Draft Regulatory Guide DG-1263 - Establishing Analytical Limits for Zirconium-Based Alloy Cladding

Subject: RIN 3150-AH42, "Performance-Based Emergency Core Cooling Systems Cladding
Acceptance Criteria"

DG-1263, Establishing Analytical Limits for Zirconium-based Alloy Cladding

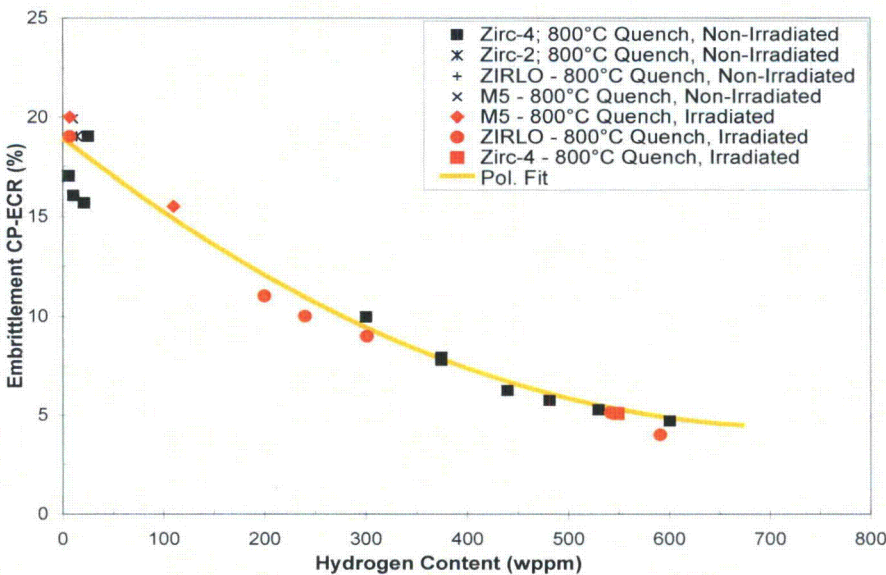
Comment	Fuel cladding fabricated from non electrolytic process source materials show consistent and stable time to breakaway oxidation. These observations do not support a concern that slight changes in the composition and manufacturing process could impact the incubation time to breakaway oxidation. Therefore, periodic testing could be removed from 50.46c and could be captured in the manufacturing qualification process.
Rationale	<p>The bulk of the breakaway oxidation test database, which encompasses fuel cladding manufactured by different vendors/processes and spans a wide range of chemical compositions, do not show short breakaway incubation time behavior. Therefore, aside from a single occurrence of short breakaway oxidation (described below), the bulk of data do not support a need for periodic testing.</p> <p>The only instance of observed significant reduction in the incubation time to breakaway oxidation is the Russian E110 cladding manufactured from electrolytic sourced material. Subsequent testing of the alloy fabricated from non electrolytic source material, using identical tubing fabrication process, showed expected incubation time to breakaway oxidation [1]. Detailed chemical analyses of the electrolytic and non-electrolytic cladding showed significantly higher fluorine content in the electrolytic processed cladding. This is expected since fluorine containing compounds are widely used in the Russian electrolytic process as a processing material. The effect of fluorine on reducing the breakaway incubation time from surface etching is well documented in the Argonne National Laboratory (ANL) research program [2].</p>
